RE: ST. Martins Hospitality Center
Grading and Drainage Plan
Engineer's Stamp Date 3-31-2017 (File: J14D182)

RE: ST. Martins Hospitality Center
Grading and Drainage Plan
Engineer's Stamp Date 2-3-2017 (File: J18D182)

ENGINEER'S SEAL	ST. MARTINS	DRAWN BY WCVJ
	GRADING AND DRAINAGE PLAN	DATE 3-20-17
		21703-LAYOUT-1-19-17
	3/21/17	 <div><i>Rio Grande Engineering</i> 1606 CENTRAL AVENUE SE SUITE 201 ALBUQUERQUE, NM 87106 (505) 872-0989</div>
DAVID SOULE P.E. #14522		JOB # 21703

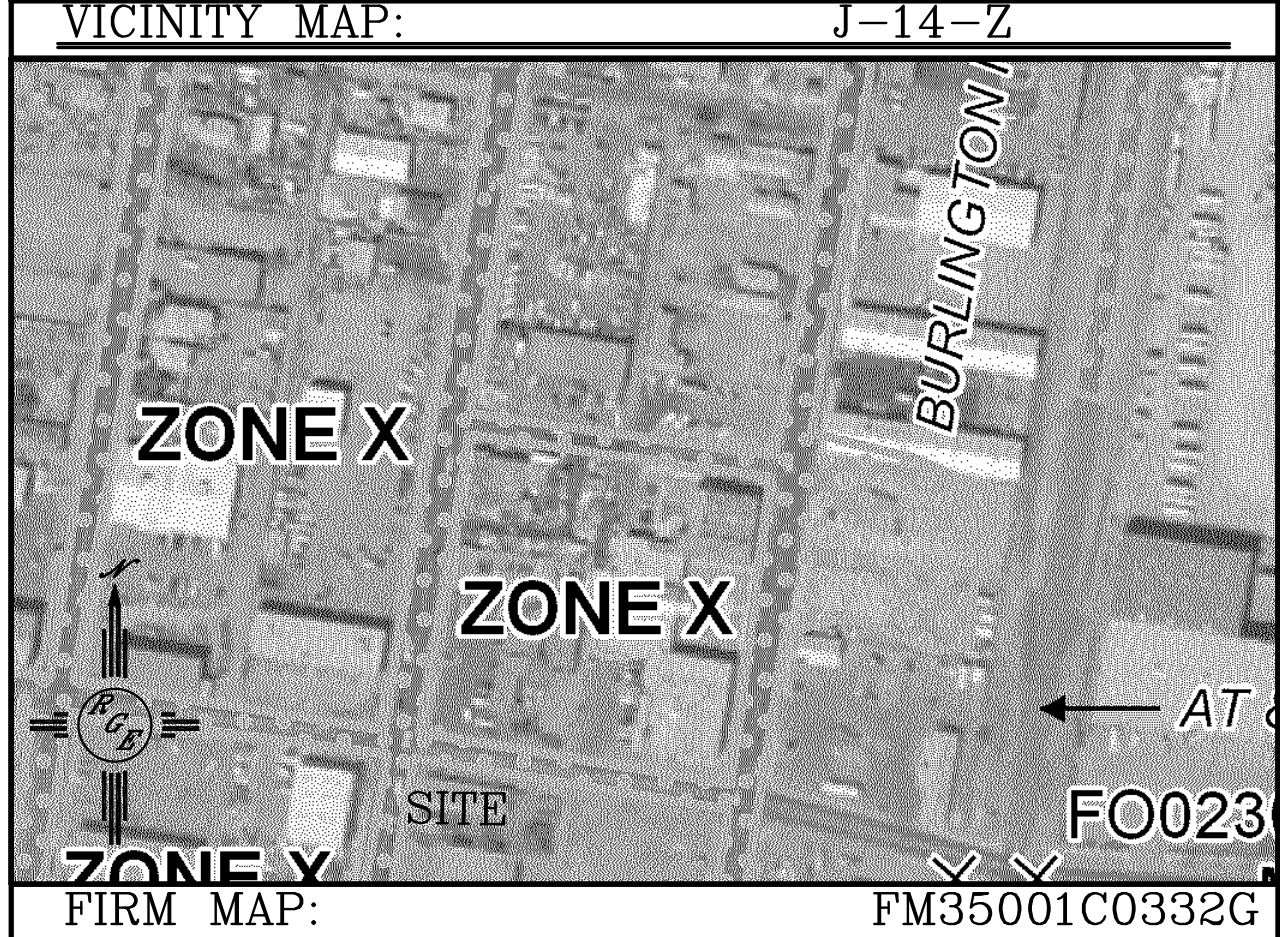
Based upon the information provided in your submittal received 2-8-2017, the above referenced Grading and Drainage Plan cannot be approved for paving permit until the following comments are addressed:

1. Provide onsite and offsite flow narrative. WE HAVE ADDED NARRATIVE
2. Hinge line between the east and west side of the site will be beneficial to get half of the onsite runoff drain to the pond or make sure stormwater quality pond placed where flow can get to it. WE HAD MODIFIED TO MAKE SURE WATER GOES TO POND
3. Peak discharge for proposed condition should be the same or less than the existing conditions. WE ARE RETAINING THE INCREASED VOLUME
4. Does the northerly building roof drain directly to Mountain Road? YES
5. Is there a trash enclosure on site? EXISTING ROLL OFF IS SHOW, SOLID WASTE APPROVED

THIS PROJECT IS THE PAVING OF AN EXISTING PARKING LOT. THERE IS NO PROPOSED CONSTRUCTION OTHER THAN THE PAVEMENT. THE SITE IS NOT IMPACTED BY UPLAND FLOW. THE SITE CURRENTLY DISCHARGES .79 CFS TO THE ADJACENT ALLEY AND ROADWAYS. THE PROPOSED DEVELOPMENT WILL MAINTAIN EXISTING DRAINAGE PATTERNS AND CAPTURE THE INCREASE IN THE 100-YEAR 24-HOUR STORM EVENT
